Proposed Changes to Lake Anne Plan Text

PLAN AMENDMENT ST06-III-UP2

Re: Lake Anne Village Center

March 18, 2009

FIGURE 42

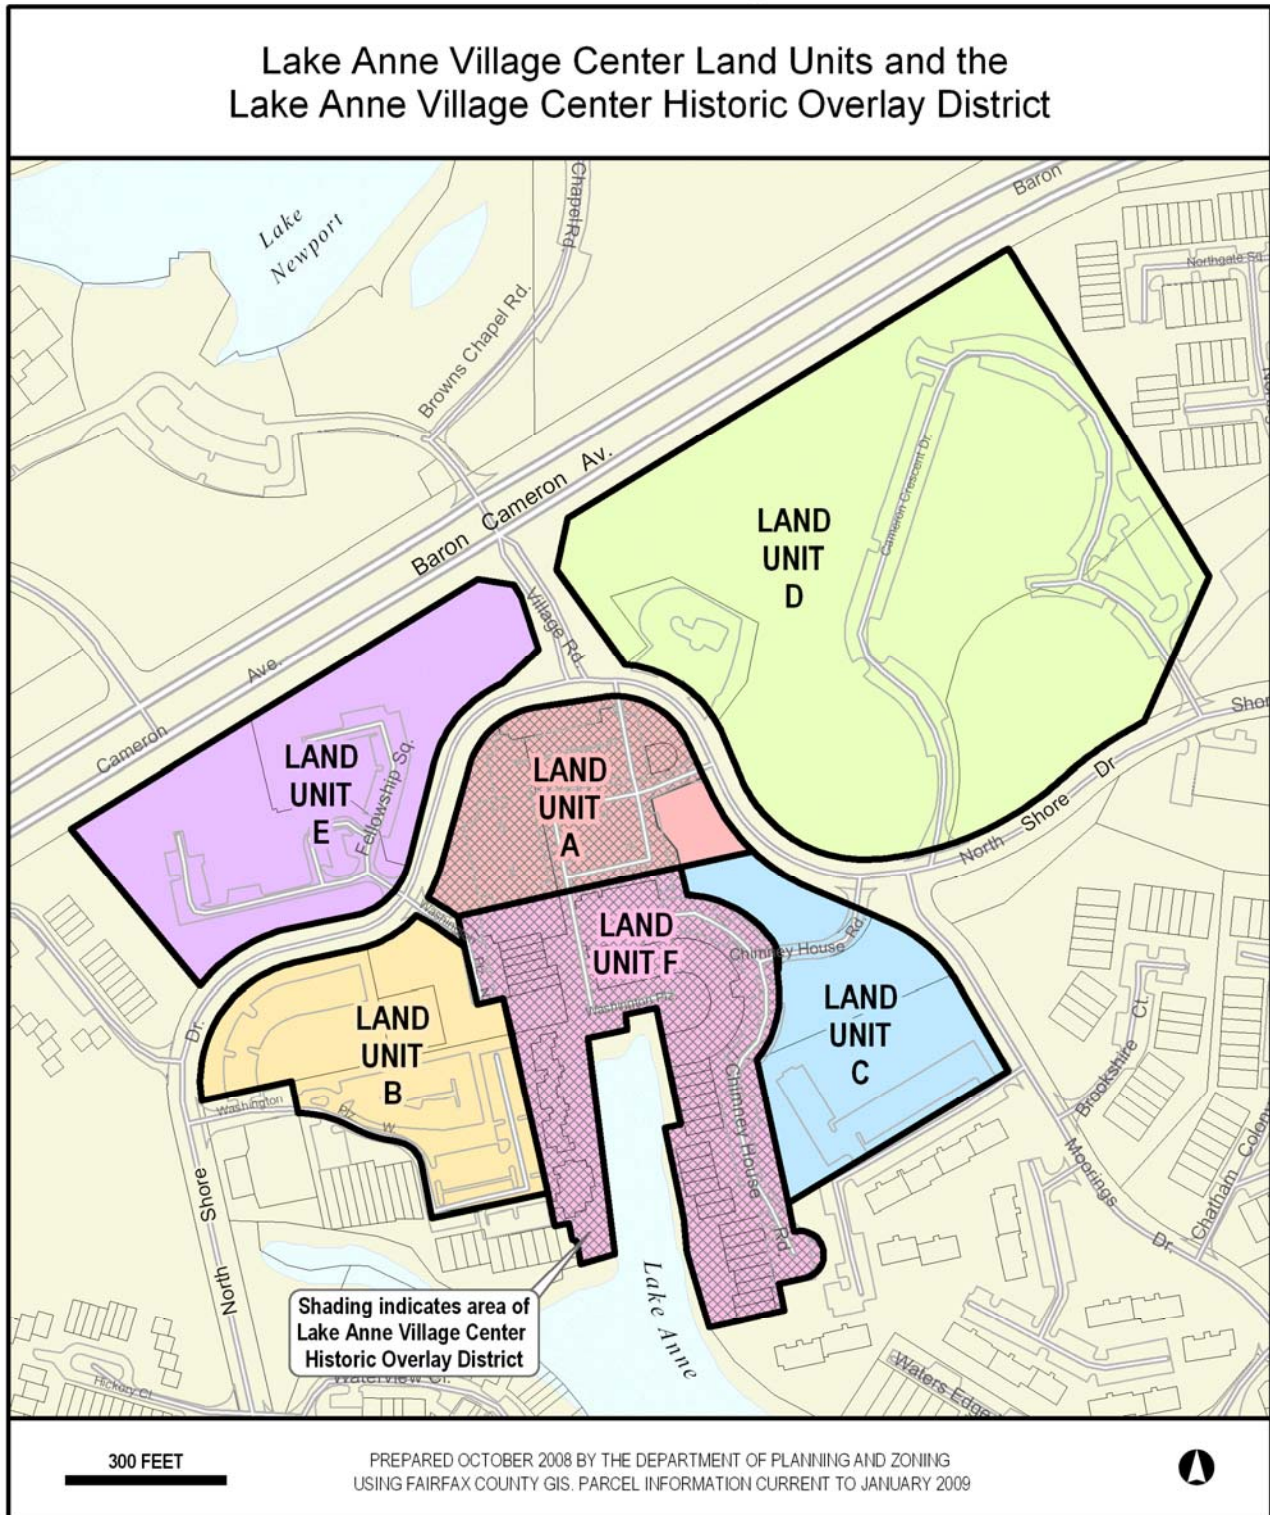
Note: Figure revised to incorporate Millennium Bank building in Land Unit F from Land Unit A.

- delete references to removing the Millennium Bank building and revise the Land Unit Map to show the bank building in Land Unit F;
- add language to the *Parcel Consolidation* Area-wide Recommendation clarifying that flexibility exists in how the *Full Consolidation Option* may be implemented;
